DRAWING AMENDMENTS

REMARKS

In an Office Action mailed on February 14, 2007, objections were made to the drawings, objections were made to the specification; claims 56-58 were rejected under 35 U.S.C. §112, second paragraph; claims 50-58 were rejected on the ground of non-statutory obviousness-type double patenting as being unpatentable over claims 1-4, 9, 19-21 and 33-36 of U.S. Patent No. 6,740,437; and claims 50-58 were rejected under 35 U.S.C. §102(a) as being anticipated by Yamada or alternatively under 35 U.S.C. §103(a) as being obvious over Yamada.

FIG. 5

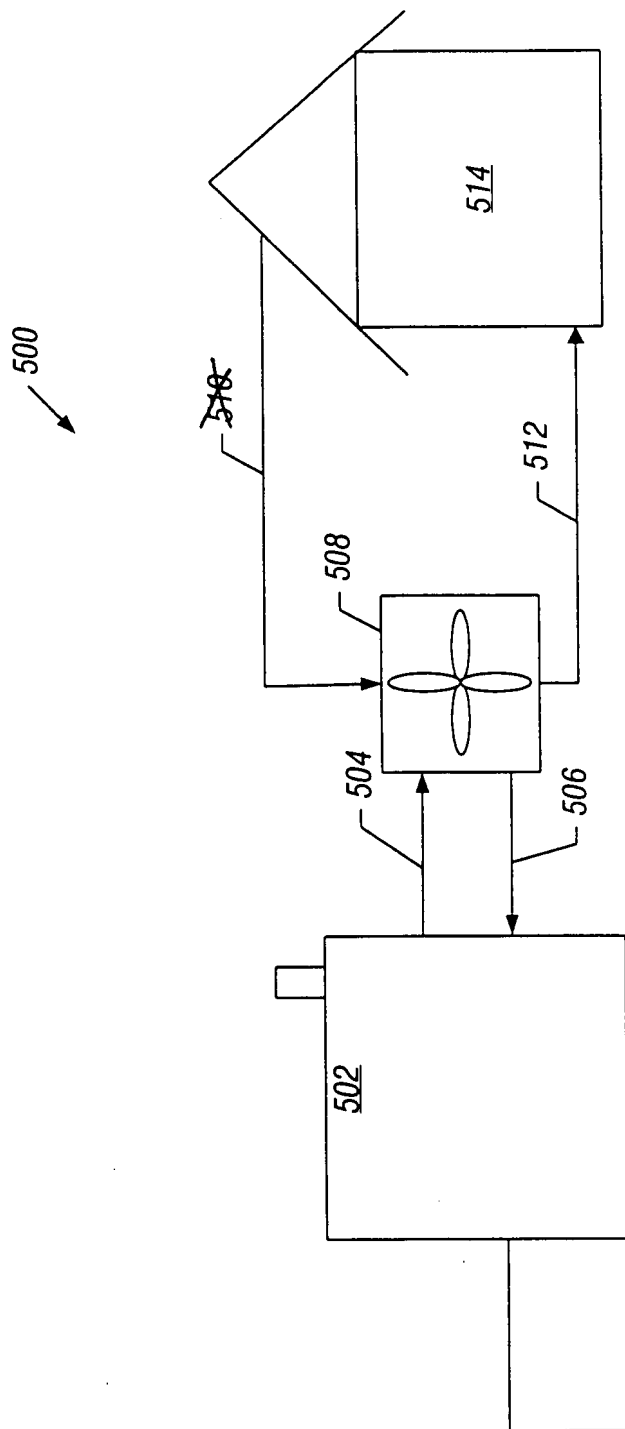
A drawing amendment is being submitted herewith, which contains annotated and replacement sheets that remove reference numerals 510, 716, 812 and 900. The specification has been amended to remove reference numeral 509. Additionally, the specification has been amended to clarify that reference numeral 320 refers to the conduit. Therefore, in view of these changes, Applicant respectfully submits that the drawing objections have been overcome.
